SUBJECT: James A. FitzPatrick Nuclear Power Plant
Docket No. 50-333
**Request for Additional Information -
Proposed Changes to the Technical Specifications
Spent Fuel Pool Storage Capacity (JPTS 90-035)**

**RESPONSE TO NRC REQUEST 2 FOR ADDITIONAL INFORMATION
SPENT FUEL POOL STORAGE CAPACITY INCREASE**

HOLTEC REPORT HI-91614
DYNARACK SIMULATIONS TO DEMONSTRATE THE ABILITY
TO PREDICT CLASSICAL NONLINEAR PHENOMENA

FIGURE 2.7

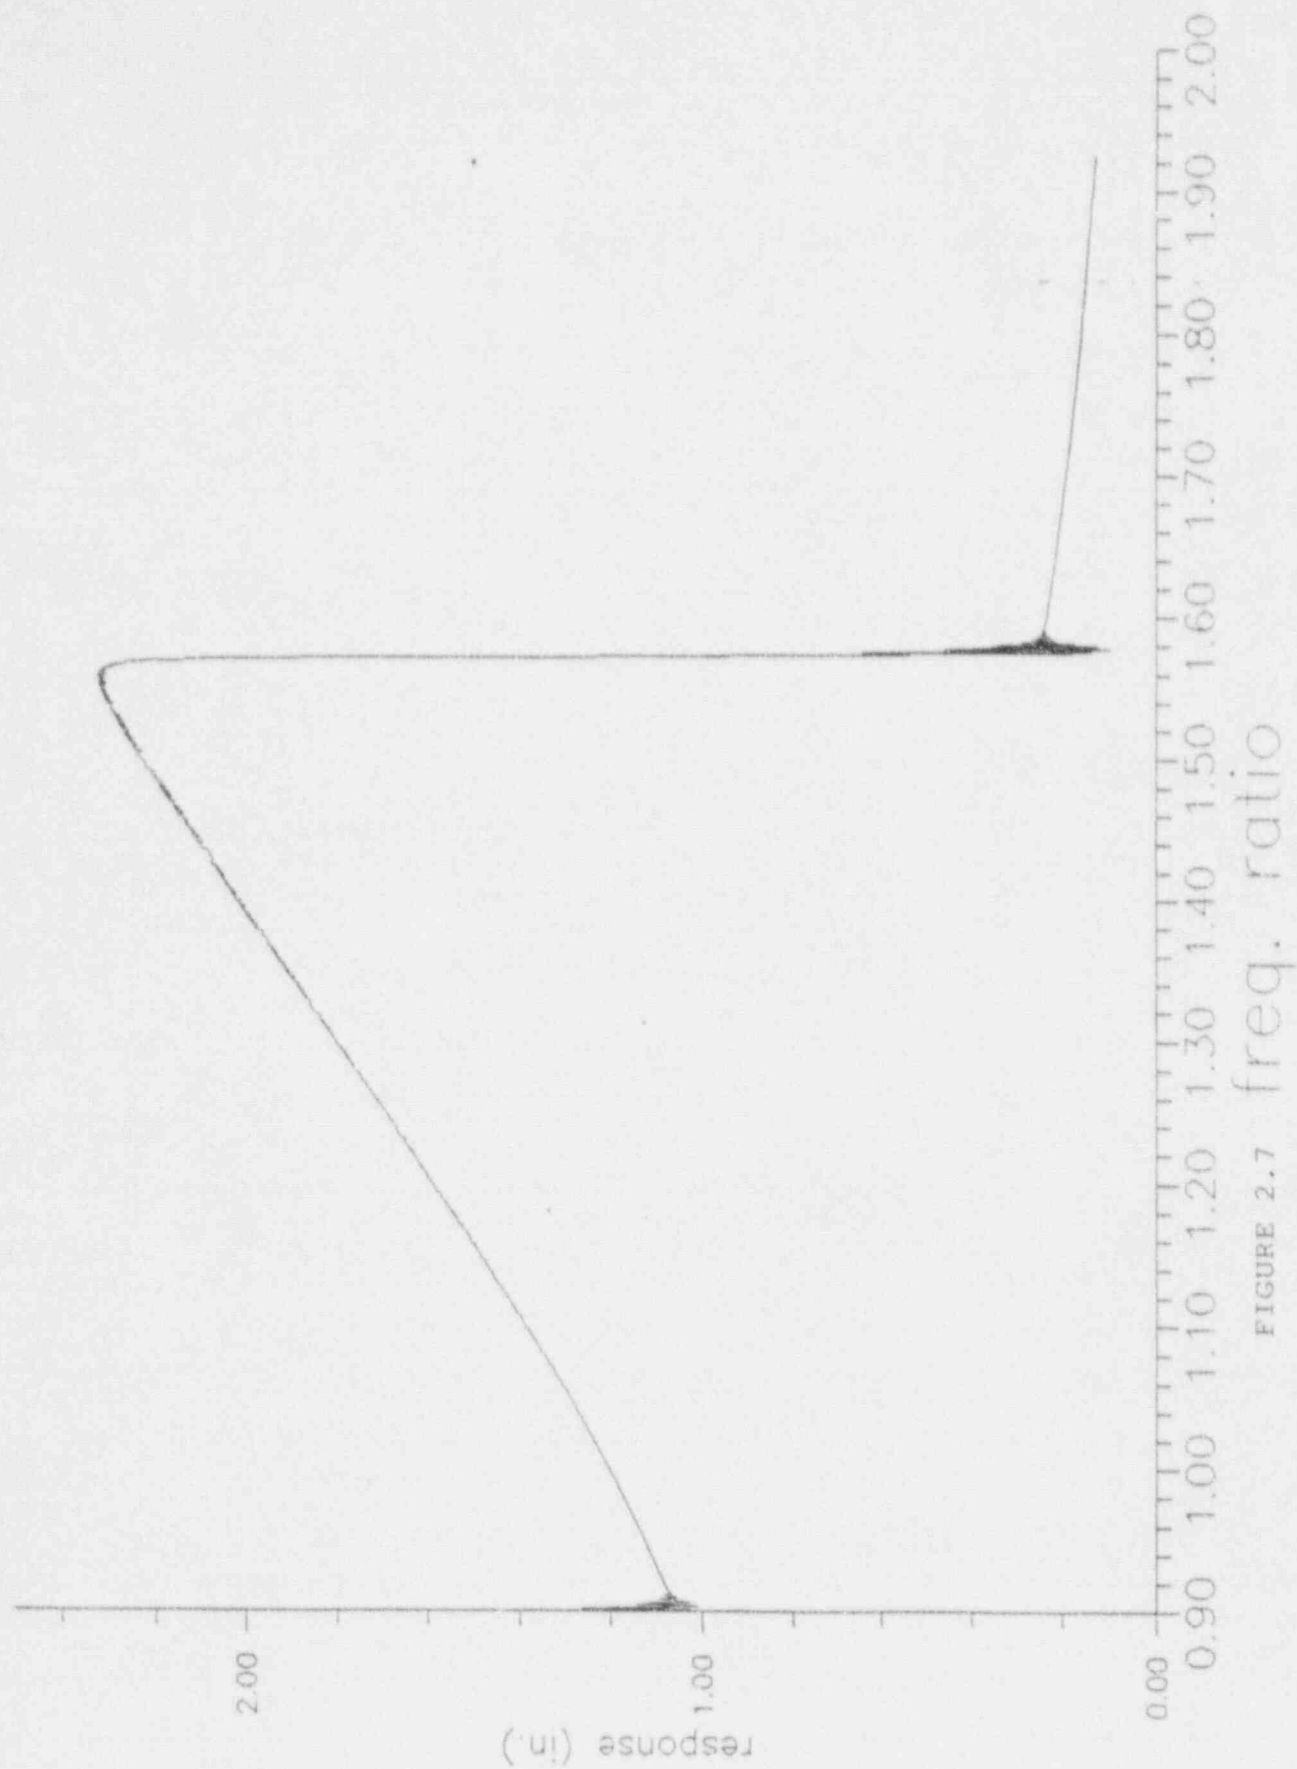
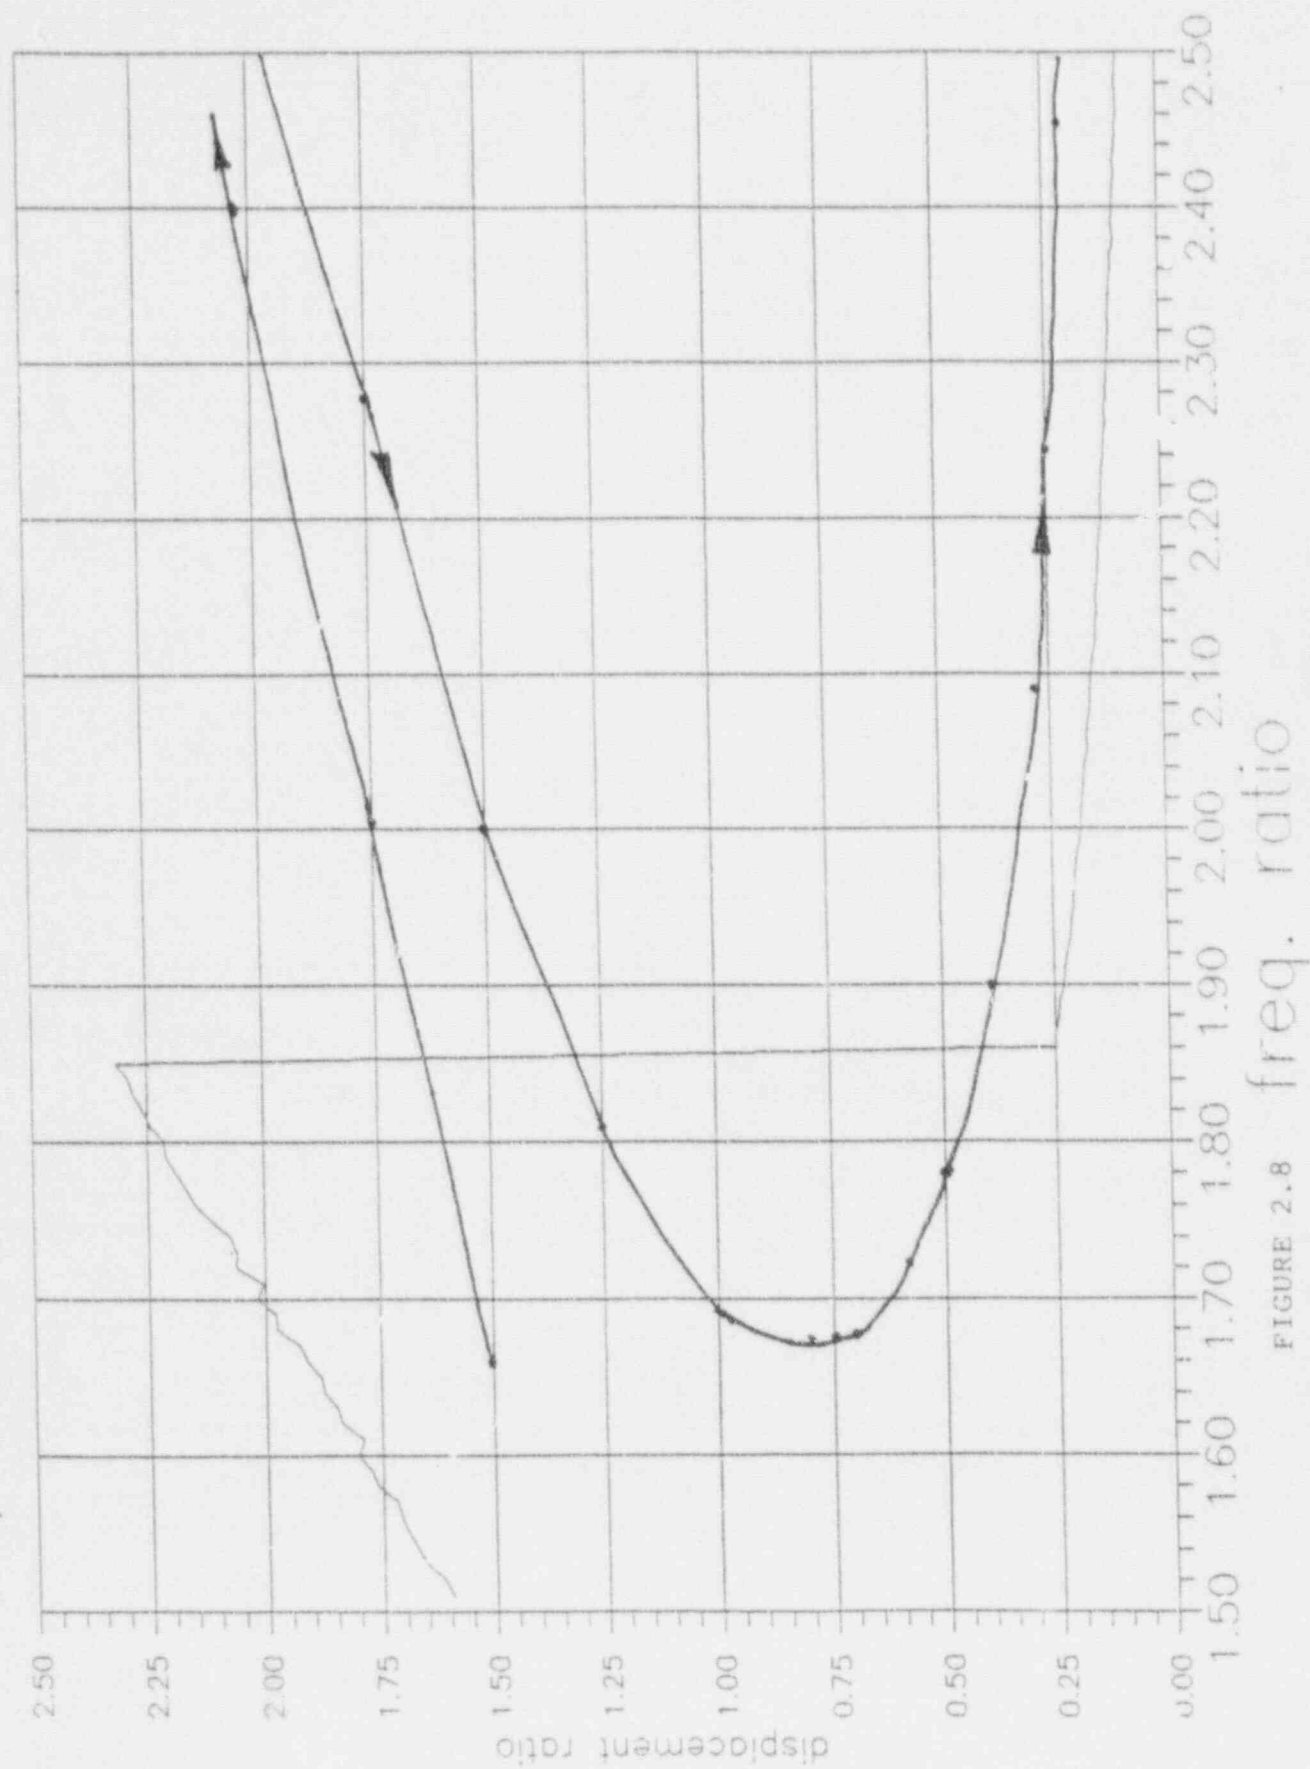
P. 6-15. It is stated that a central difference scheme is used for solution of the governing differential equations. Demonstrate how such a scheme can adequately depict various response phenomena, such as, subharmonic, bifurcation, and instability associated with nonlinear dynamics. Provide a specific example for such demonstration similar to that provided in references (1) and (2). Discuss how error associated with numerical integration is assessed and accounted for in a similar manner as that of reference (3). Also provide verification of the computer results with available experimental data.

lower curve, to the inflection point, and then abruptly increase to the higher branch. It is found in actual shaker tests that the onset of the instability is sensitive to the sweep rate of the shaker. We attempt here to demonstrate the ability of DYNARACK to predict a jump phenomena. We simulate the resonance curve by doing a time history analysis with $E_1 = 1$, $\delta = .2$, and v_1 slowly increased from a value less than 1.0 rad/sec. The sweep rate is set low enough to be able to ascertain the maximum response amplitude. Figures 2.7 and 2.8 show the result of the DYNARACK simulation. Figure 2.8 also contains the two branches of the resonance curve plotted from Table C-1 in Appendix C. Both figures show that the simulation code is able to model the jump instability; however, the results show that the onset of instability is sensitive to the time step size. Figure 2.7 represents a run for 100 seconds with step size .004 sec. while Figure 2.8 shows the curve obtained with a step size of .0001 sec. We see that the amplitude at the onset of instability is relatively insensitive to the step size but the frequency at which the instability occurs is sensitive to the step size. It is apparent that to exactly follow the resonance curve (itself an approximate solution), an extremely fine step size is called for. We did not attempt any modeling of the resonance with a decreasing forcing frequency.
